Rezoning Review Briefing Report – RR-2024-35

Springfield Road North Precinct, Catherine Field (2,000 homes and 254 jobs)

Rezoning Review – Briefing Report

RR-2024-35 (PP-2022-1275)

Figure 2. Original draft Indicative Layout Plan (Planning Proposal, 2022)

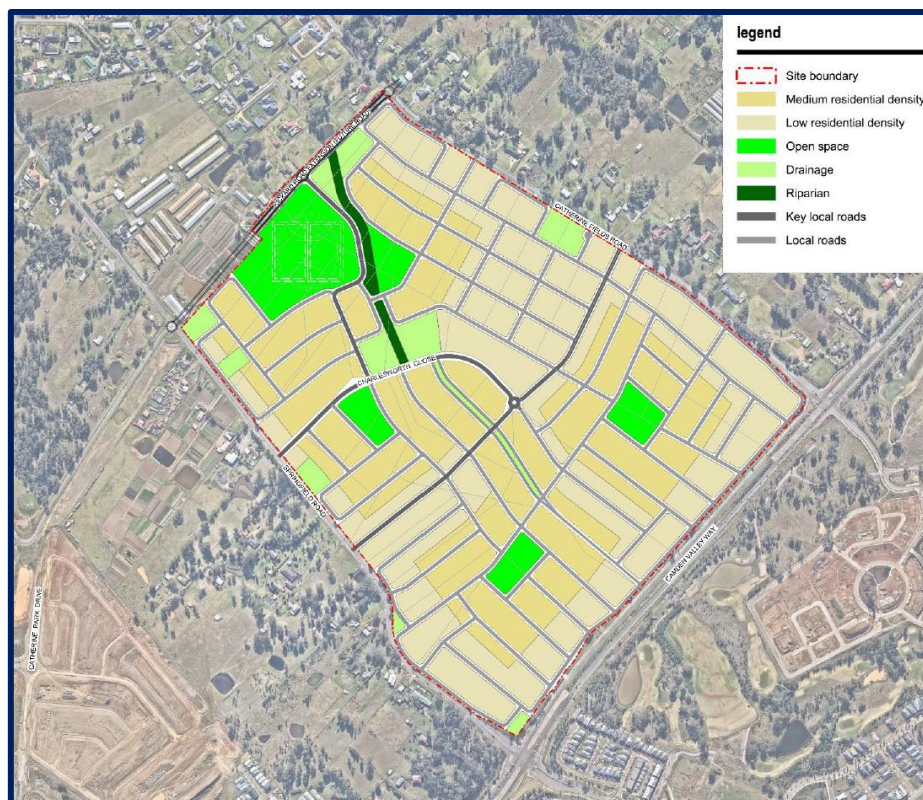
- Additional information on the proposed residential zoning, residential density bands and building heights are required to ensure the draft ILP options can support housing diversity, rather than just low density detached residential housing.

- There is a need to review proposed locations for medium to high residential density areas in the preferred draft ILP option and introduce mapped minimum lot sizes.

- There is a disconnect between open space, green links and the street network in the draft ILP options due to block length, street network design, and a lack of landscape and public domain master planning.

- The addition of the local centre has provided an opportunity to introduce higher residential densities and a broader range of housing options. Although the updated ILP options include the addition of around 5.5ha of non-residential uses, the dwelling yield remains around 2,000.
- Most of the site is less than 5% slope and almost the entire site has less than 10% slope. Ridgelines and high points are on the site boundary and will be considered as requirements for the building form and design.
- The draft ILP will deliver a significant portion of open space, a riparian protection area and drainage that will connect to the Riley Creek catchment land. These green spaces create

Figure 7. Flood affectation on the site based on original ILP (Source: Camden Council's Upper South Creek Flood Study)

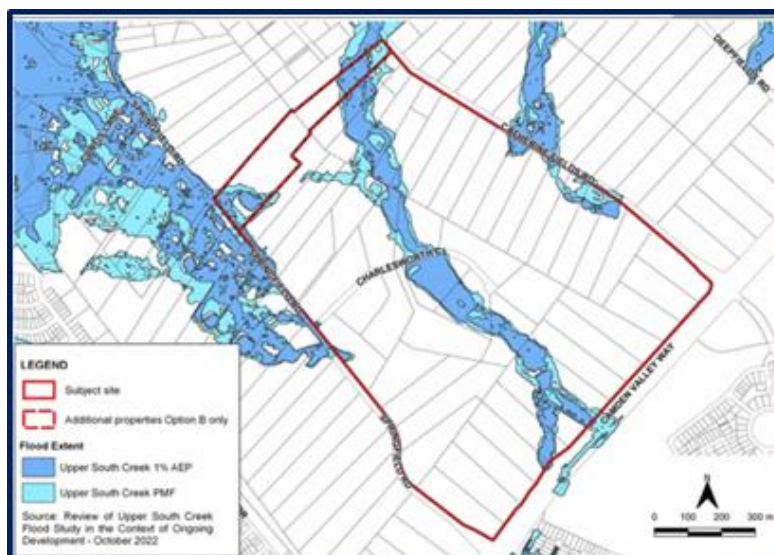
- The site is mapped as being within the 1% Annual Exceedance Probability (AEP) and the Probable Maximum Flood (PMF) (**Figure 7**).

- The NSW SES have reviewed both the original ILP and updated ILPs and have noted:
 - The original ILP raises concerns about the proposed detention basins' ability to accommodate for PMF flows, impacts to lots and roads affected by 5% AEP and PMF and that shelter-in-place is not supported; and
 - The revised ILPs have incorporated positive changes (from previous advice), however:
 - i. the medium to high density residential is located at the highest flood risk;
 - ii. sensitivity testing is needed for potential failure of the basins;
 - iii. green and spaces and riparian corridors should be appropriately sized to prevent dwellings from encroaching onto areas of high flood risk and;

- iv. the SES does not support any strategy which requires people or vehicles to enter flood water.

- Revisions to flood modelling and Water Cycle Management Strategy (**Attachment A6**) and a Flood Impact and Risk Assessment (FIRA) are required to ensure that the draft proposal and preferred draft ILP option can meet the requirements in Section 9.1 Direction 4.1 and address the comments from the SES.

- The site falls under the 1% and 5% AEP and PMF flood events. All flood events mapped can be contained within the proposed drainage corridors and network of detention basins and bioretention basins.
- Parts of the site at the southern boundary may experience minor flood spillover in the 1% AEP event, which will be addressed at the Development Application (DA) stage along with refinements to the design of the basins.

Figure 8. Bushfire affectionation on the site (Source: Spatial Viewer, 2025)

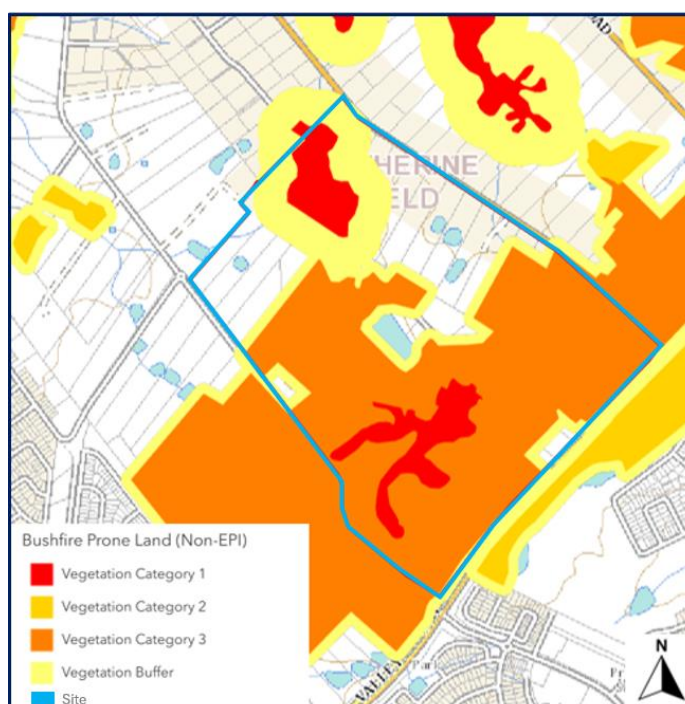
- The site is mapped as being bushfire prone (**Figure 8**).

- The NSW RFS comments state The ILPs are generally in accordance with *Planning for Bush Fire Protection (PBP) 2019* (**Attachment A4**), however, a revised bushfire assessment is needed for the revised ILPs.

- The site is mapped as bushfire prone land, with areas identified as Vegetation Category 1 (**Figure 8**). APZs will need to be provided between the assessed riparian protection area and residential development adjacent to the riparian corridor. APZs have been mapped in the supporting Bushfire Assessment (**Attachment A4**).
- Bushfire threat has been assessed, and it is concluded that the original draft ILP can meet the objectives of *Planning for Bushfire Protection 2019*.
